SSD-77175998 – 194-214 OXFORD STREET & 2 NELSON STREET, BONDI JUNCTION

Response to Submissions Report

Figure 1 Update to Basement Level 4

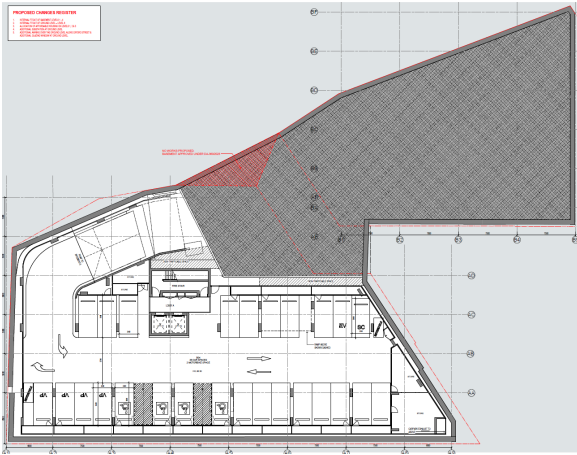
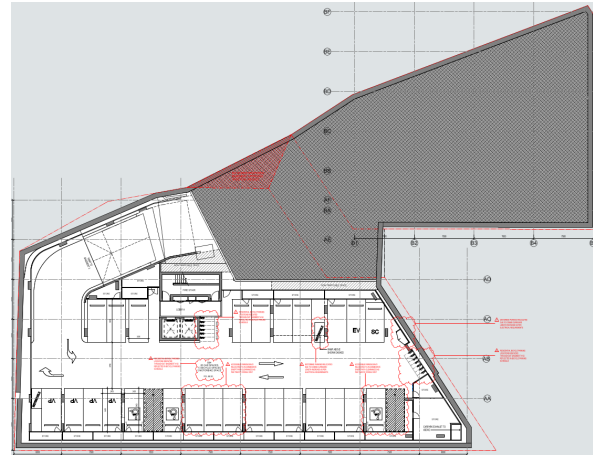
Overview of Refinements to the Project
Updates to Basement Parking, Storage as well as Bicycle Parking
Updates were made across Basement Levels 1, 2, 3, 4 as well as the ground level with the main objectives of refining the development design to address the following:

▪ Provide Bicycle Parking Consistent with the DCP Requirement: in accordance with the Waverley DCP bicycle parking rates (under Section 7.2.6 of the Waverley DCP, 97 bicycle parking spaces are required), updates have been made across the basement and ground levels to deliver a total of 98 bicycle parking spaces. This includes: – 13 bicycle spaces at Basement Level 4 – 28 bicycle spaces at Basement Level 3 – 28 bicycle spaces at Basement Level 2 – 29 bicycle spaces at Ground Level ▪ Updates to Basement Layout to ensure compliance with the relevant Australian Standards and Swept Path requirements. ▪ Continued Provision of Appropriate Storage Areas (Basement) and Car Parking Spaces: in tandem with changes to the basement layout to address the above, the updates to the basement levels maintains the same total number of car parking spaces and provides the required quantum of storage space. It is noted that in the updates to the basement layout, the updated basement will provide 25 accessible parking spaces in lieu of 28 in the previous revision, however, this was as there was a surplus of 3 accessible parking spaces, and the proposed 25 accessible parking spaces complies with the NCC 2022 accessible parking requirements. Similarly, the provision of motorbike parking remains the same.

Figure 6 Update to Level 01

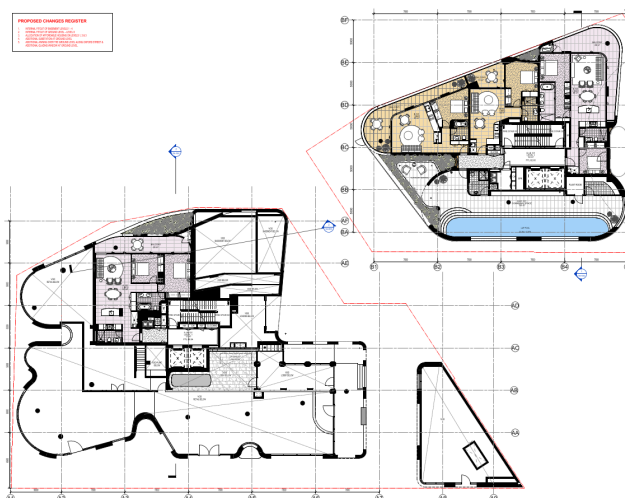
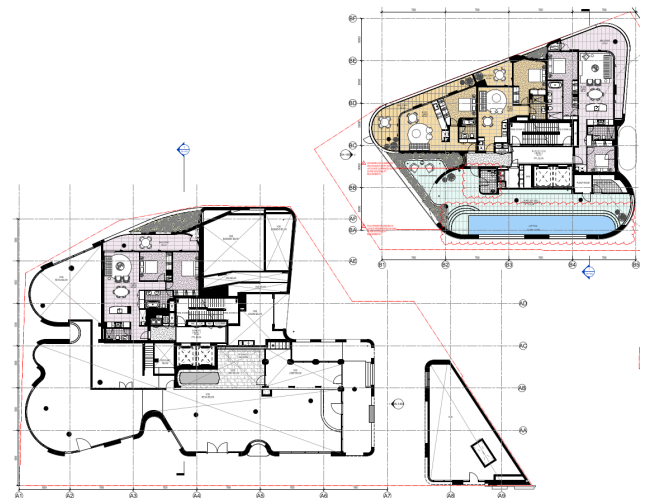
Accessibility Refinements
Detailed design refinements have been made across the communal spaces of the building in accordance with the recommendations of the Access Assessment Report prepared by East Coast Accessibility Pty Ltd. Further detail of how these design refinements have been made to address the accessibility requirements is provided at Section 5 of this Rts report.
Norfolk Pine Tree
During the assessment period for this SSDA, the existing Norfolk Pine Tree was found to be dead and decaying after it was struck by lightning. The tree had failed at its base and was considered to dangerously overhang Syd Enfield Drive. As such, immediate removal of the Norfolk Pine Tree was required and the tree was approved to be removed and replaced as part of the development consent, DA-400/2021/E (approved 29 May 2025). As such, this SSDA has been updated to be consistent with the approval for the planting of a mature 800L Norfolk Island Pine at a similar location as the original, Norfolk Pine Tree.

Picture 19 Approved View 9

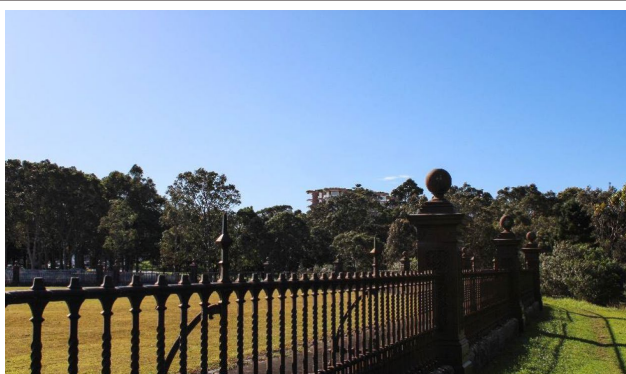
The visual impact from Viewpoint 9 is **moderate**. This is as:

- the existing view approved under the existing approval site is visible from this point with the approved development recognisable above the existing mature vegetation.

- It is important to note that the level of pedestrian footfall at this viewpoint is minimal, given the open space associated with the reservoir is gated and not publicly accessible nor is there an official designated footpath provided in this location. Therefore, it is not likely that many visitors will observe the proposed development from this viewpoint.

- While the additional storeys are more prominent than those previously approved on the site, the stepped design helps to soften their visual impact, echoing the natural variation in height and form of the surrounding tree line.

- From this viewpoint, other urban features are visible outside the park, including structures on Oxford Street, Bondi Junction. These existing structures contribute to the broader visual context and diminish the dominance of the proposal within the overall view.

- The proposal's high-quality design, particularly the variation in building heights (to compliment the proposed increase in height), materials and finishes are considered fundamental to ensuring a positive visual and built form outcome and ultimately minimising adverse visual impacts. Furthermore, the presence of trees will partially screen and soften the visual impacts of the new development from this viewpoint.

- The viewpoint is of exceptional significance.
- The additional visual impact, as a result of the proposal, will be minor due the additional storeys which are visible above the tree line. The proposal as approved was visible from this vantage point, and forms part of the high density built form in the area. The limited increase in built form results in a minor additional visual impact on the view from the Reservoir, however, would not impede on views and vistas from the reservoir to the rest of the Centennial Park.

Table 2 Updates to Accessibility Assessment

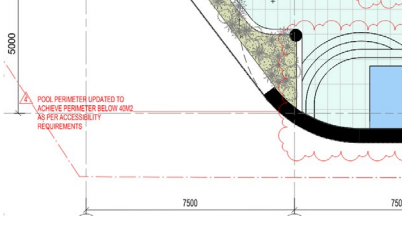
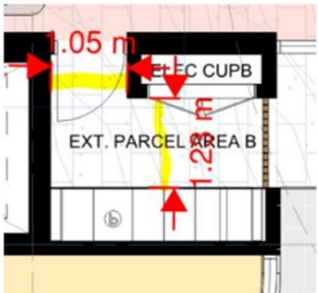
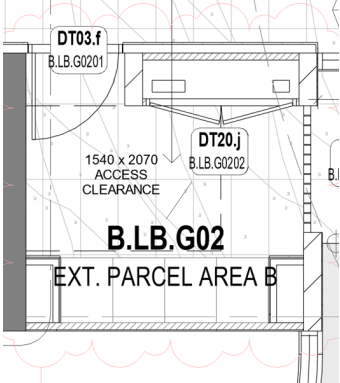
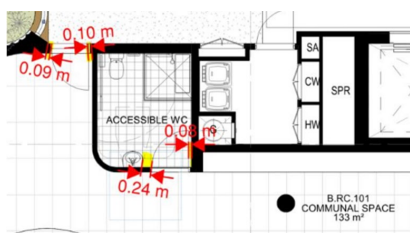
Exhibited Access Report Comment	Updated Architectural Design Response	Updated Access Report Comment
D4D2 Level 1 As lap pool in gym area is more than 40m in perimeter an accessible entry into the pool is required. Communal area is required to be accessible, latch side clearance is required. 	The current L1 pool to be built on site has a perimeter of 38.2m², meaning accessible entry into pool is not required. SJB has updated the Architectural Drawings (Appendix A) to reflect L1 pool perimeter to be under 40m as per site condition. 	Provide details of pool entry prior to CC
Redesign for further assessment.		
D4D2 Ground floor – parcel area B If parcel area is to be accessed by all occupants, latch and hinge side clearance is required internally. If there is to be another parcel area for occupants please advise. 	Adjustments to wall thicknesses made to respond to area compliance. 	Latch and hinge side clearance is still required. If parcel locker area in building A is accessible to all occupants in case an occupant with a mobility impairment cannot access the Building B parcel area, this will suffice.

Redesign.	Otherwise, a performance solution to be prepared for adaptable users to access Building A parcel lockers.	
D4D3 Ensure all doors will have a clear opening of 850mm (920mm doors are recommended to achieve this). The doors also require compliant latch and hinge side clearance with AS 1428.1. Please see D4D2 & D4D3 for specifications. Level 01 Circulation space at the doorway doesn't comply (300mm required between basin and door latch)	SJB has updated the Architectural Drawings (Appendix A) to match current CC documentation under the parent consent, which achieves required clearances and circulation as per Australian Standards.	Complies

Redesign for further assessment. 'Still required'
